Consideration of Petition No. RP-052-14, Max Fuller, Owner, and Moore Bass Consulting, Inc., Agent, request to add six (6) lots to the Minor Subdivision Plat for Max Fuller, with said property being located in Land Lot 87 of the 5th District and fronting on South Jeff Davis Road.

RE: Rezoning Petition 1235-14 and Revised Plat RP-052-14
South Jeff Davis Road Subdivision
MB Project No.: A41.008

PETITION NO: 1235-14 & RP-052-14

SHEET TITLE
CONCEPTUAL PLAN
SHEET
1.0

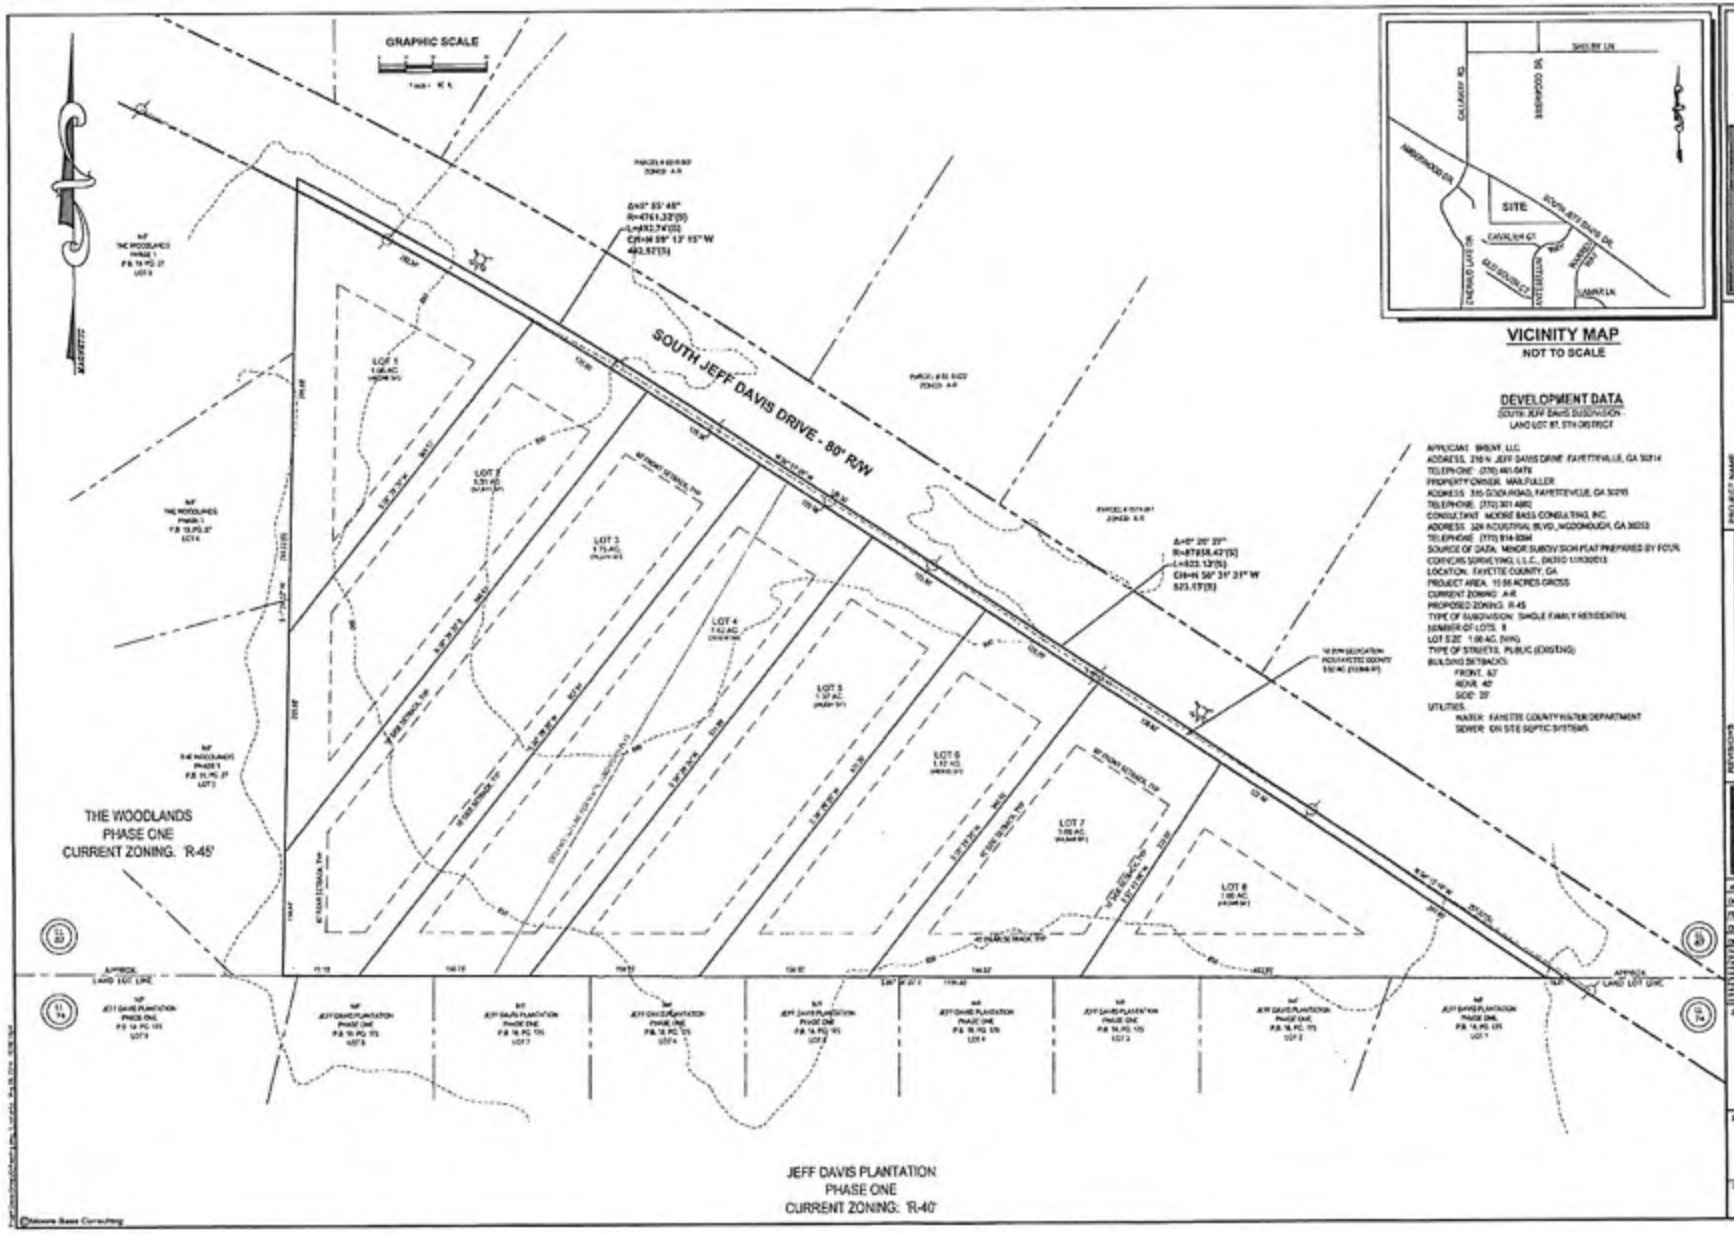
The Concept Plan submitted indicates eight (8) possible access points from South Jeff Davis Drive. South Jeff Davis Drive is classified as a Minor Arterial road on the Fayette County Thoroughfare Map. The applicant shall be aware that Public Works/Engineering has concerns with adequate site distance and may require shared driveways (see below).

- Bottom line seems to be that sight distance has been checked by the applicant and appears adequate for all lots. Plus option for shared driveways on lots 6 and 7, if needed.
- For final plat we'll have to double check these and possible require access easement on the appropriate lots.

The applicant shall be aware that the Environmental Management Department has concerns with storm water runoff and its effect on downstream properties (see below) and the Environmental Management Department will make a determination at the time of the Minor Subdivision Plat Revision.

1. The proposed rezoning increases number of possible curb cuts onto South Jeff Davis Road from 2 to 8 and adequate sight distance may not be available at all locations. Staff recommends that applicant determine sight distance at each proposed lot on the Revision to the Minor Subdivision Plat. Shared driveways (maximum of two homes per driveway) may be required. We do not want to create, via rezoning, a lot with safety issues to future homeowners or traveling public.

2. The increase in density will allow four times the impervious area without requirement for storm water management since no new road construction. This may impact downstream lots in Jeff Davis Plantation. Environmental Management has more input on this issue.

- Lots 1 and 2 have basically unlimited sight distance to the west or left and approximately 525-600 feet of sight distance to the right. I determined this by standing next to the fire hydrant in front of proposed Lot 1, which put my eye level at about 3.5 feet above where a driveway would be, and measuring the distance to the mailbox I could see across the street from Lot 4. I repeated this exercise in front of Lot 2.

- The lots that would be considered along the top of the hill, Lots 3, 4, and 5, have well over a thousand feet of sight distance in both directions.
- Lots 6 and 7 appear to present the biggest sight distance challenge. In my opinion, because the vertical curve in the road is so long and gradual, the required sight distance is achievable from every possible driveway location. However, if these two lots are close enough to cause concern an option could be to have them share driveways with the lots on either side of them. In other words, Lots 5 and 6 could share a driveway along their common boundary line and Lots 7 and 8 could share a driveway along their common boundary line.
- Lot 8 is more than 500 feet from the top of the hill and therefore over 500 feet of sight distance exists to the left. Sight distance to the right is well over a thousand feet.
